TURNER LAKE DAM
DENT COUNTY, MISSOURI

MISSOURI INVENTORY NO. 30266

PHASE I INSPECTION REPORT
NATIONAL DAM SAFETY PROGRAM

SEPTEMBER 1978

TURNER LAKE
PROFILE AND X-SEC.

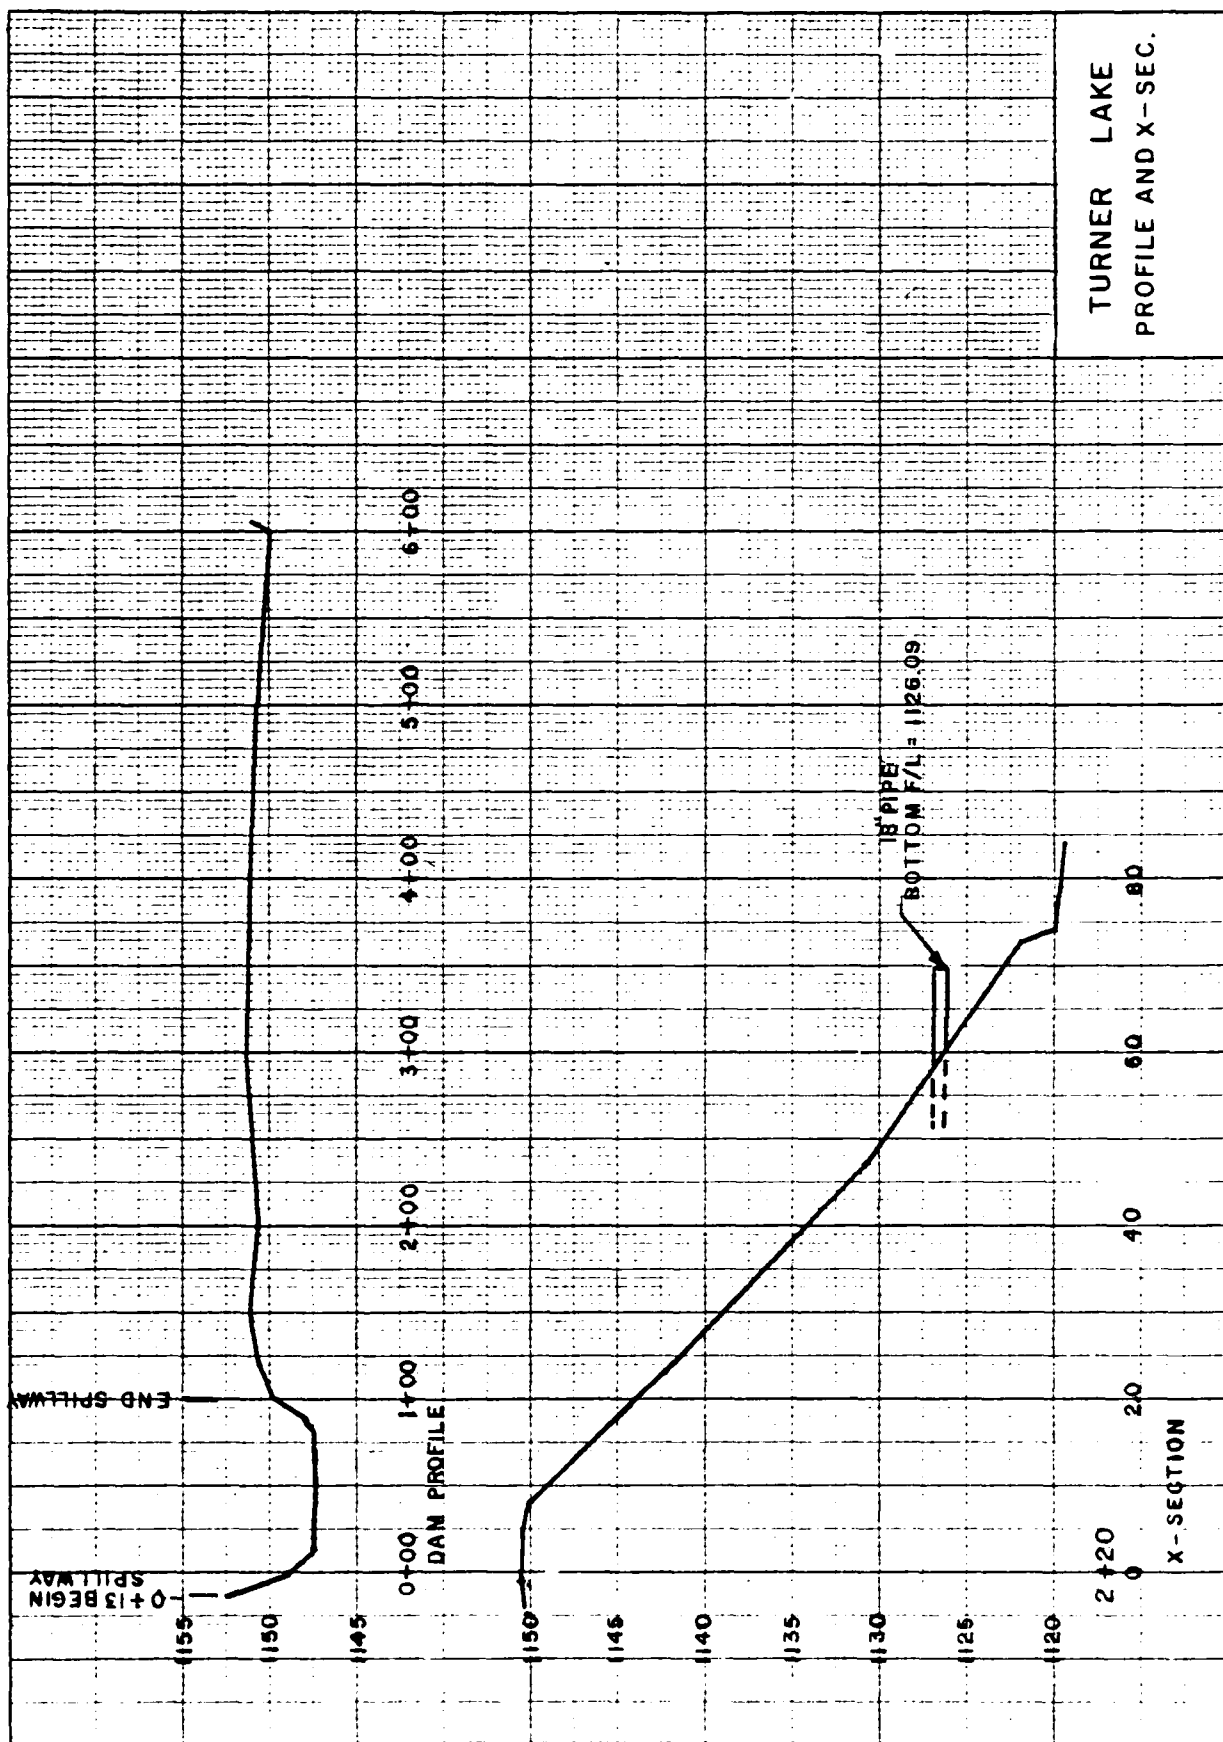
An embankment cross-section near the maximum height for the dam is shown on Plate 3. In a few areas, the embankment slopes are considerably steeper than the section shown. It is difficult to determine the reason for the irregular slopes especially since there was heavy vegetation on the slope but it appears that the slope has experienced some sliding. There is a slide scarp in the area adjacent to the outlet pipe up from the toe of the dam where seepage is exiting from the embankment. The slides are not large but they do pose a danger of progressive failure of the embankment. No burrows were noted but some could be present and masked by vegetation.
